INDESIT company

Model type:
TAAN3VS

Commercial code:
F038574

51420c0 Exploded views

N1025154FIG1

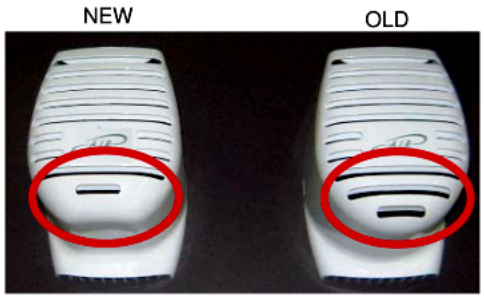
## n1025154: New fridge '05 mechanical 175/60 motor fan cover (Indesit)

From serial number 51101.0001 the motor fan cover (C00114748) has been modified to eliminate interference with rear edge of glass top in the models listed below.

The photo N1025154FIG1 shows the difference between the new cover and the old one. See area circled in red.
